RIT-T ASSESSMENT: SOUTH AUSTRALIA ENERGY TRANSFORMATION

A FINAL REPORT PREPARED FOR THE AER

Frontier Economics has been engaged by the Australian Energy Regulator (AER) to independently assess the economic analysis and modelling undertaken by ElectraNet in support of its South Australian Energy Transformation (SAET) RIT-T application.

Figure 26: Investment levels and capacity factor of storage in 'AER Sensitivity 1'

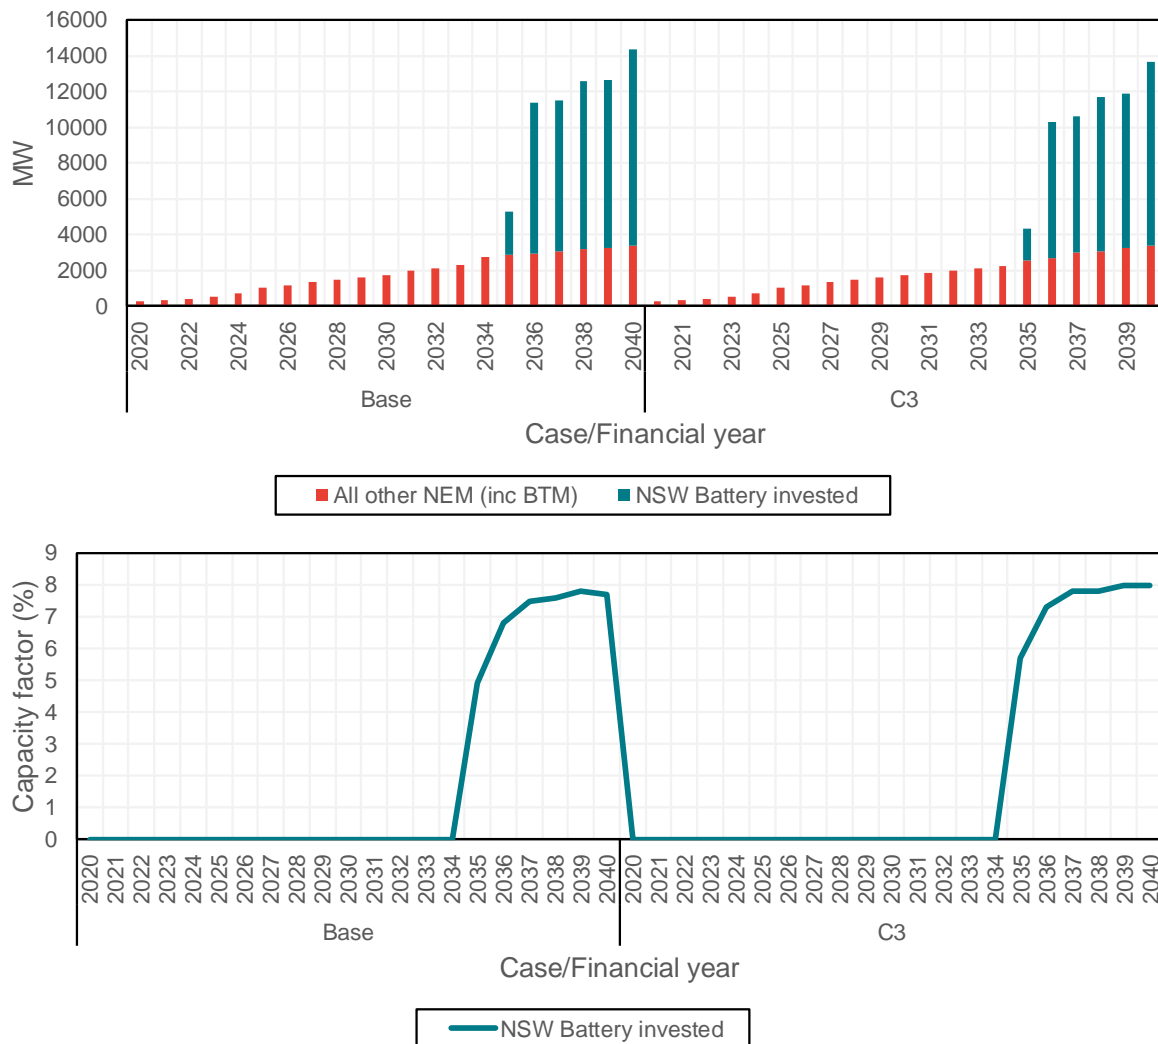
The storage build cost category is \$221m more expensive in the Base state of the world than the Option C3 state of the world due to more investment by the model in Northern SA pumped hydro and NSW utility-scale batteries. These contribute \$64m and \$157m NPV respectively to the total build cost category difference – that is, there is NPV \$64 million worth of Northern SA pumped hydro and NPV \$157m of NSW battery built by the model in the Base case that is not built in Option C3.

While additional storage in the Base state of the world is a likely outcome without the presence of an interconnector, the battery investment in NSW is substantial and appears to be driven by factors other than pure economics. In both the Base and Option C3 states of the world, a large amount of NSW battery is built, but infrequently utilised, as illustrated in **Figure 26**. **Figure 26** illustrates the total amount of storage in the NEM in the top panel, including behind the meter storage, compared with the magnitude of NSW battery investment. The bottom panel illustrates the capacity factor of this NSW battery in each state of the world, which ranges from 5-8%, which roughly corresponds to one daily cycle or less for two hour storage.

Figure 27: Difference in firm capacity and utility battery investment, NSW (Base – C3)

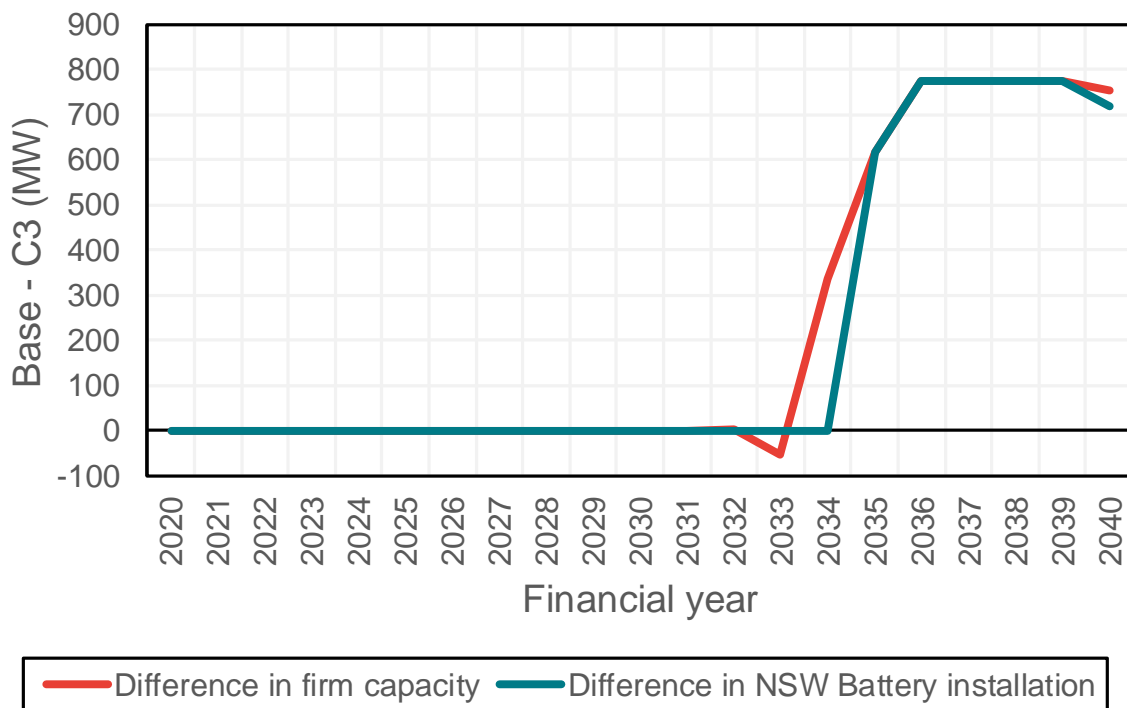
It appears that this battery investment is a result of the reserve margin constraint binding in NSW from 2033. Modelled investment in batteries increases over time as peak demand grows, and these batteries have low utilisation rates. Battery storage is one of the cheapest forms of non-derated generation available – i.e. one of the cheapest ways of meeting the reserve margin constraint.

The difference in firm capacity between the base and C3 states of the world is mostly constant from 2036, suggesting that the firm capacity requirements (i.e. the total reserve margin) in the base case are approximately 775MW higher in the base case than in the C3 case. The difference in firm capacity from the Base and C3 cases is illustrated in **Figure 27**.
